SERVICE BULLETIN 89-1

SUPER LOOPS

SERVICE BULLETIN 89-2A

Bulletin No.: L03-001  
Release Date: 02/24/03  
Effective Date: Immediately  
Supercedes: N/A  
Completion Date: 03/31/03  
Page: 1 of 4

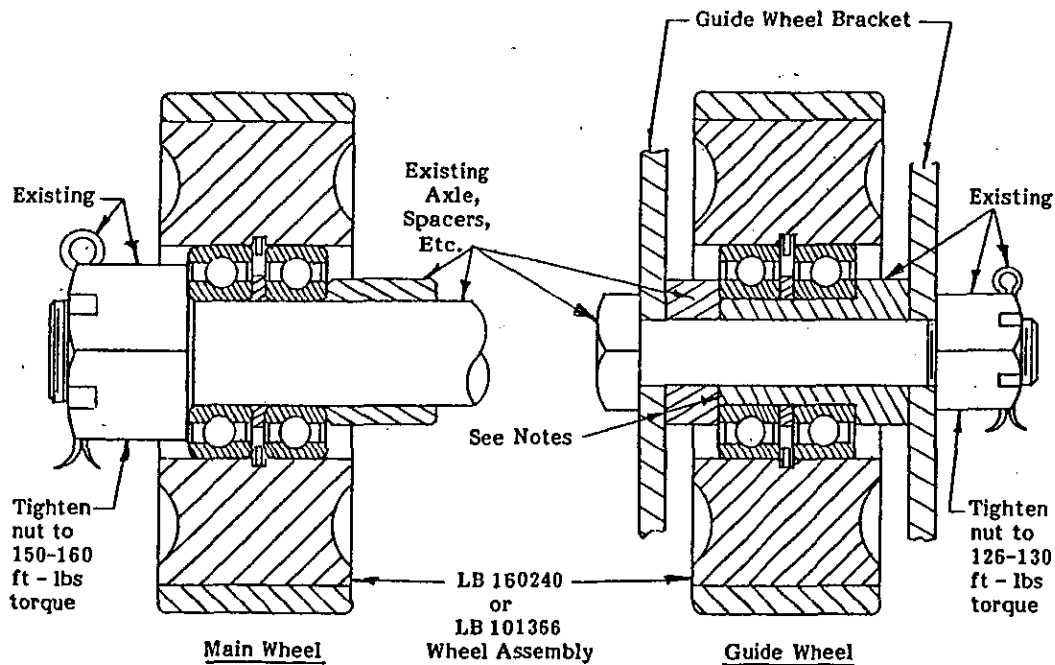
Starting immediately, replacement wheels for Super Loops will be either aluminum wheels with molded urethane tires, Part No. LB160240, or nylon wheels, Part No. LB101366. These wheels will come assembled with sealed ball bearings and internal spacers. This is a direct replacement for wheels with tapered roller bearings (Timken). These wheels are sold only as assemblies to insure proper installation of the bearings, retainer rings and spacer. Installation of the bearing is shown below and uses the existing spacer(s), axle and nut. Since these bearings are prelubricated and sealed, no further lubrication is required resulting in less maintenance and a cleaner ride.

- Notes:
1. Two piece spacer must make up solid to prevent bolt from turning in brackets.
 2. Check holes in brackets for wear if bolts have been allowed to spin. Repair if necessary.

SERVICE BULLETIN 89-2

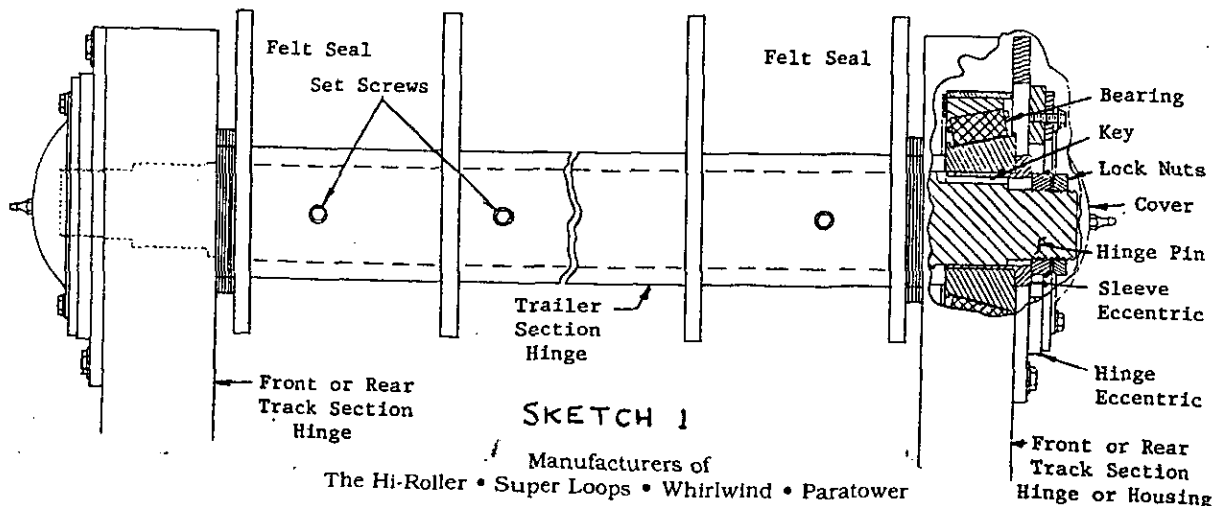
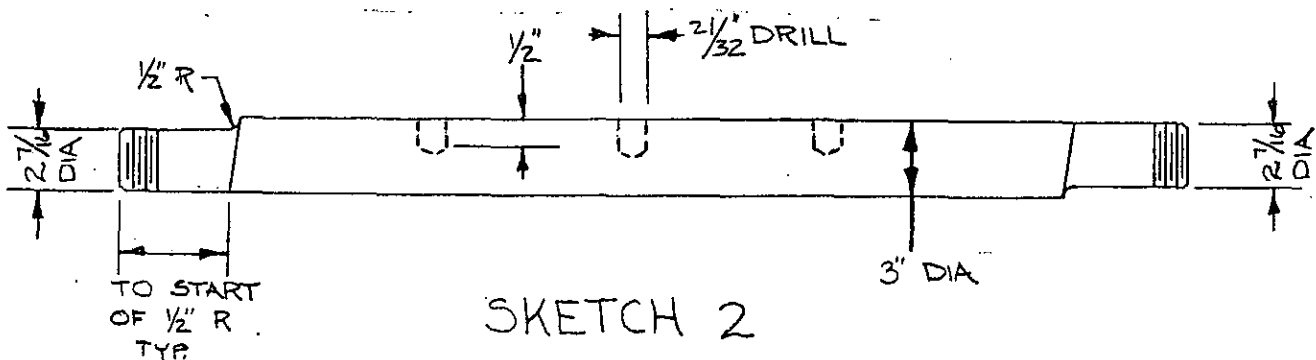
CAUTION: IT IS ABSOLUTELY necessary to replace the original or a new hinge pin in exactly the same position as the original pin was installed. If this is not done properly the track will not align and a very dangerous situation will be created.

Remove the cover from each end of the hinge. See Sketch 1. Mark the position of the hinge pin, sleeve eccentric, hinge eccentric, and the hinge housings. Mark both ends and use different markings on each end so that the parts will not get mixed. A number stamp works well so that each pin and each end of each pin will have a different number. These markings must be oriented so that the parts will be replaced in the same place and direction as their original position.

SKETCH 2

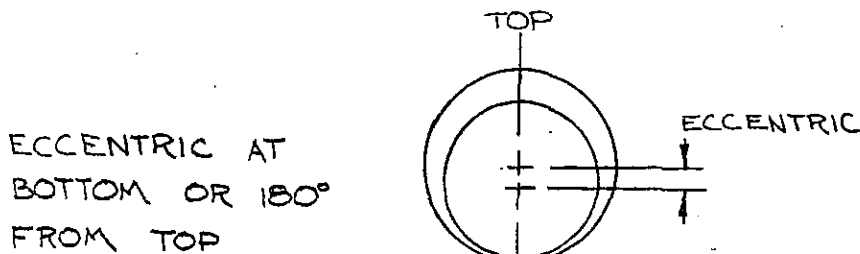
To reuse a pin that has been found free of cracks, it must be remachined as shown in Sketch 2. This increases the corner radius, reducing the stress concentration of that area. Reuse of a pin without this change is not permitted.

If a new hinge pin(s) is ordered, place the old pin next to its replacement so that both are oriented the same. Mark the new one the same as the old. The three (3) set screws holes are not predrilled. This is to be done at assembly to insure proper position of the holes. Install the pin into the hinge housing. The pin should protrude equally out each end of the hinge housing. Align marks as previously set during disassembly. With the three setscrews removed, mark the positions of the setscrew holes on the hinge pin with a center or prick punch. Remove the pin and drill each center with a 21/32 inch diameter drill with the full diameter going 1/2 inch deep as shown in Sketch 2.

FIGURE 4

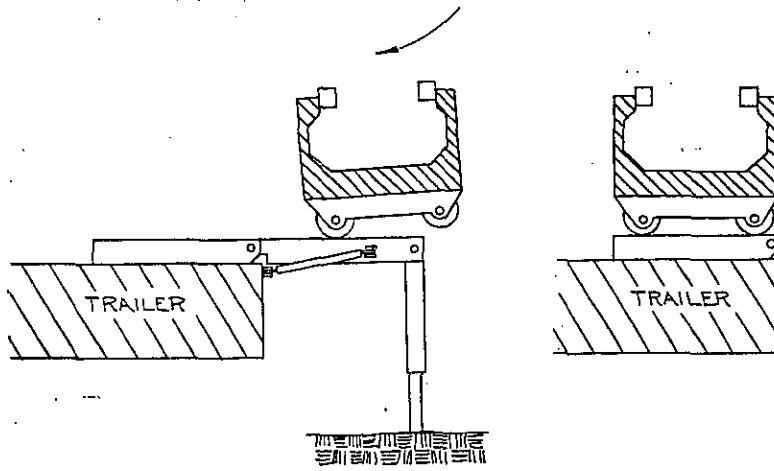
To help prevent fatigue cracks, all Super Loops were provided with transport carriers, Figure 4. When the track is lowered to the trailer for transport, a set of wheels mounted on the track engage a ramp, lifting the free end of the track onto the transport carrier. When the track is completely down, this carrier, through a parallelogram linkage, further lifts and supports the free end of the track. At this point, the ramp wheels should have some clearance (1/16 to 1/4 inch) with the ramp. If the ramp, ramp wheels, and/or the transport carriers are damaged or missing, they must be repaired or replaced. If the transport carrier does not lift the ramp wheels off the ramp, shim or modify as necessary.

SERVICE BULLETIN 89-4

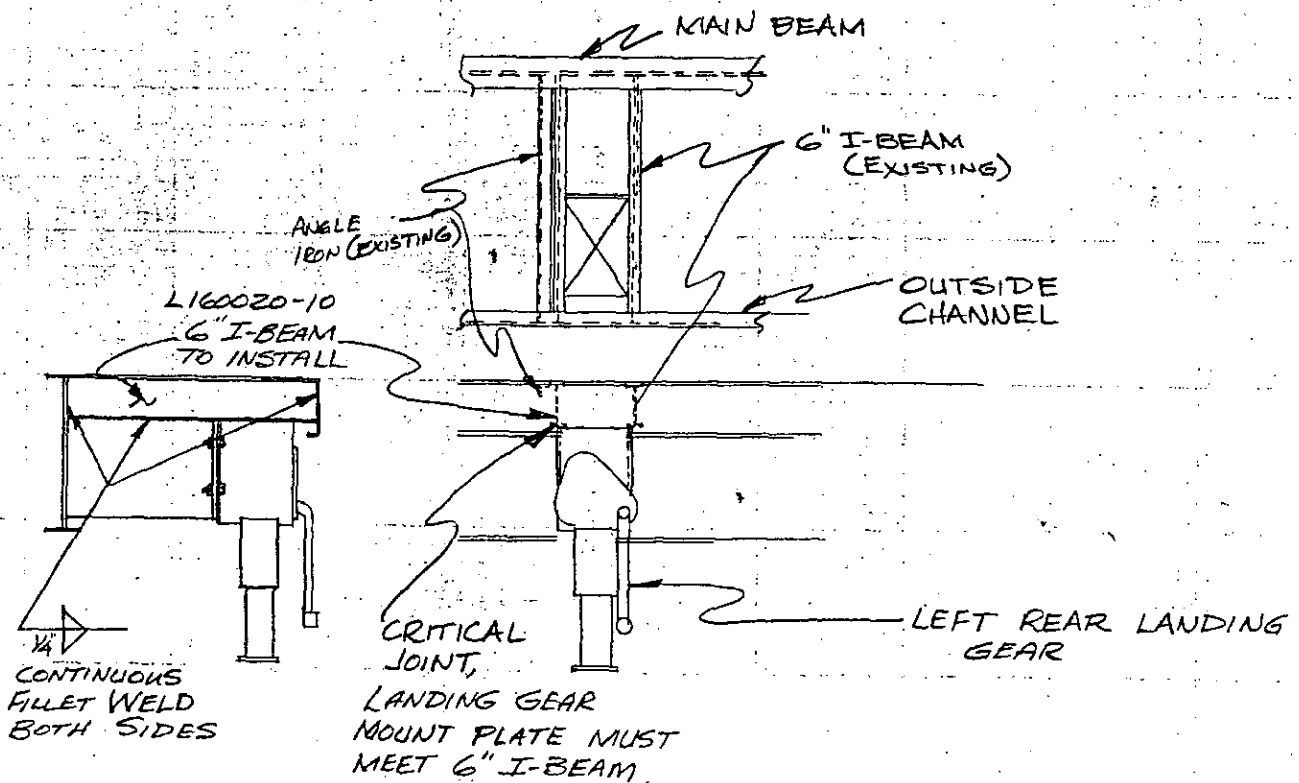
It has been brought to our attention that the landing gear on the left rear of the trailer may lack proper support. This situation should be investigated immediately. It involves Serial Numbers 44 through 50 trailers only.

SEE SKETCH BELOW. The landing gear should be tied into two (2) 6" I-beams. If the front I-beam is missing, there may be only an angle iron brace in its place, but will not be tied in to landing gear mount plate.

Please advise the manufacturer so that we can supply the ride operator with a 6" I-beam to repair the situation. If, upon inspection, there is no problem found, please let us know so it can be filed in our records.

SERVICE BULLETIN 91-1

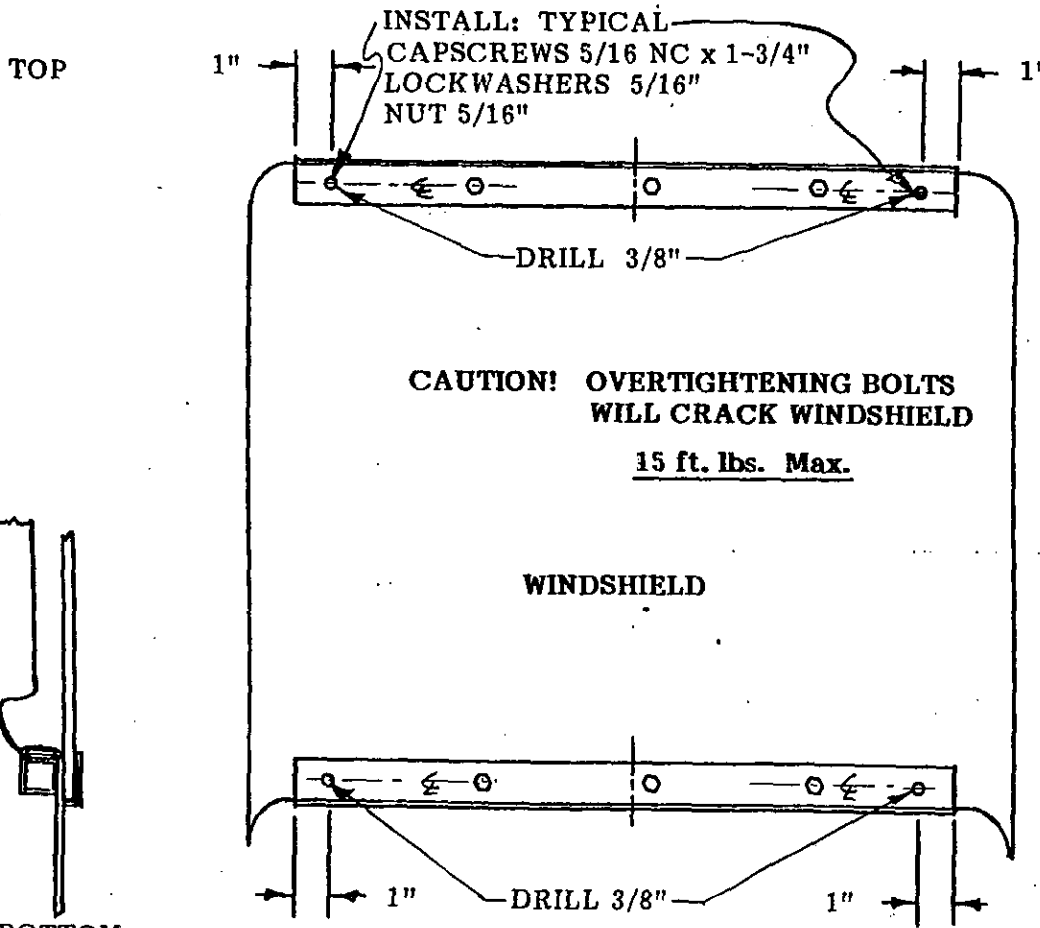
ADDITIONAL CAPSCREWS REQUIRED FOR CLAMPING WINDSHIELD  
S/N 3 thru 7

THE TWO BOLTS HOLDING KNEE PAD ALONG THE BOTTOM SHOULD BE REMOVED<sup>①</sup> AND KNEE PAD POSITIONED<sup>②</sup> SO THAT WHILE DRILLING THE TWO NEW HOLES THE PAD WILL NOT BE DAMAGED.

- 40 EA H101250 CAPSCREWS 5/16" NC x 1-3/4"
- 40 EA H300030 LOCKWASHERS 5/16"
- 40 EA H200030 HEX NUT 5/16" NC
- 2 EA DRILL BITS 3/8"

## SERVICE BULLETIN 94-2

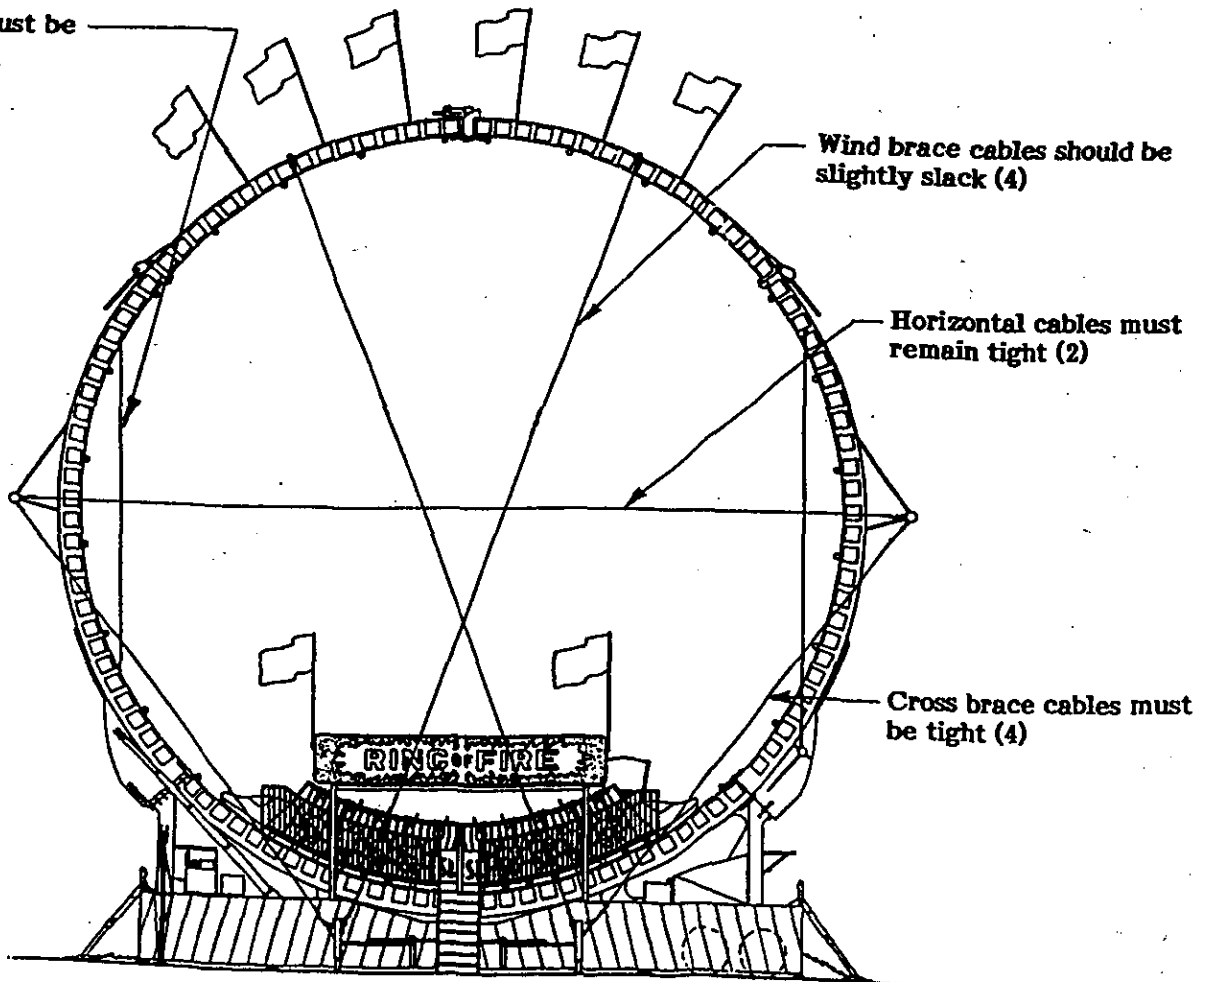
The purpose of this bulletin is to alert ride operators/ride inspectors of the proper cable tensions for Super Loops (Ring of Fire). The illustration below depicts the proper cable tensions on the horizontal and cross brace cables. The two (2) erection cables shown, for illustration ONLY, must be removed before any passengers are allowed on this ride. The reason the erection cables must be removed is so passengers cannot reach hands and arms outside the train and grab the cables.

The reason the wind brace cables must not be tight is to keep the track a true circle. These cables, when overtightened, will crush the circle into an elliptical shape. This causes extreme pressures on the jactuators and the train axles during operation.

**CAUTION: THE ERECTION CABLES MUST ABSOLUTELY BE REMOVED FROM RIDE BEFORE PASSENGER OPERATION. DO NOT TIE ERECTION CABLES TO TRACK DURING OPERATION - REMOVE CABLES FROM RIDE!**

Erection cables must be removed for ride operation (2)

Figure A

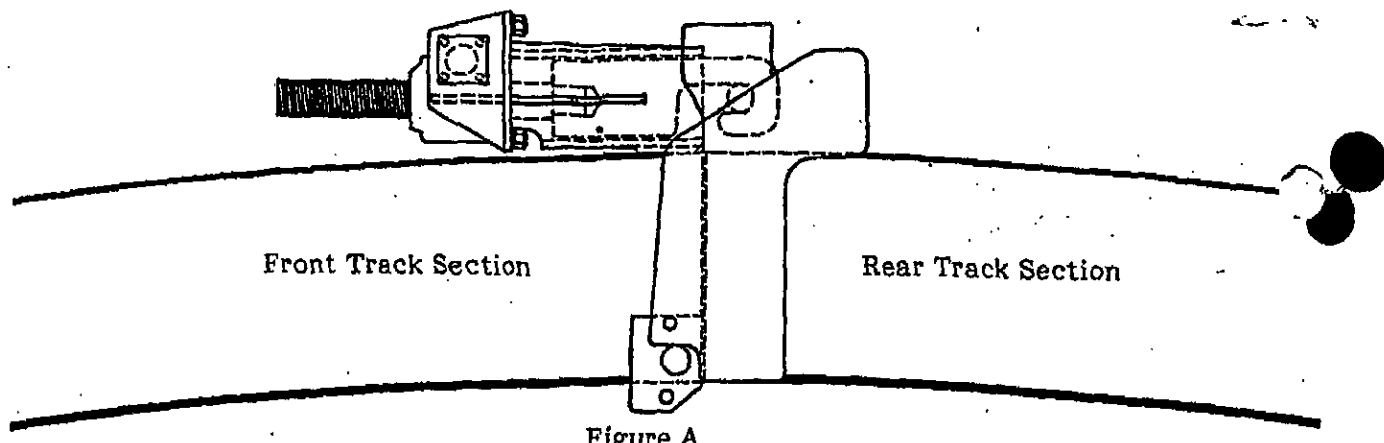
Recently there have been several incidents of breaking the top hook. THERE IS NO WAY THE TOP HOOK CAN BE BROKEN UNLESS IT IS BY IMPROPER TEAR DOWN PROCEDURES. It is apparent that untrained personnel are being allowed to erect and tear down the Ring of Fire (Super Loops). It is imperative that all owners re-check the erection/tear down procedures and follow the instructions in the owners manual, on the decal at the control valves, and as shown in the erection video tape.

The only way the top hook can be broken is by extending it past the limits as marked by red paint and the operator trying to bring both sections down at the same time or bring the front section down first. The top hook should be extended only far enough to clear the guide rollers (See Figure B). The operator should then be able to lower the rear track section allowing the roller to come out of the top hook through the gap provided (See Figure C). If the roller remains at the outer end of the slot in the hook, then the leveling jacks must be adjusted so that the roller is at the back of the slot and free to come out of the gap when the track section is lowered, i.e. the hook should push the rear track section back thus opening the track and clearing the dowel pins. Roller must rotate freely and should have a coat of wheel bearing grease.

Figure C

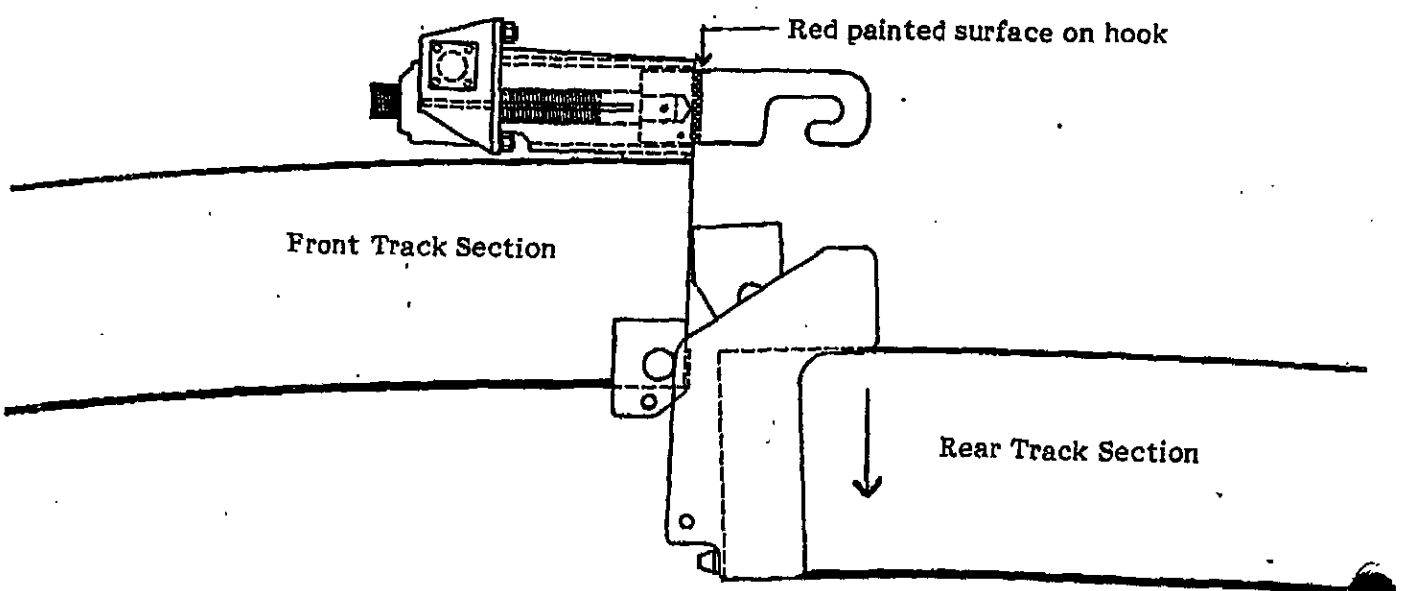
Note: Illustrations shown without top safety lock turnbuckles for simplicity purposes only. These turnbuckles must be in place before operating with passengers.
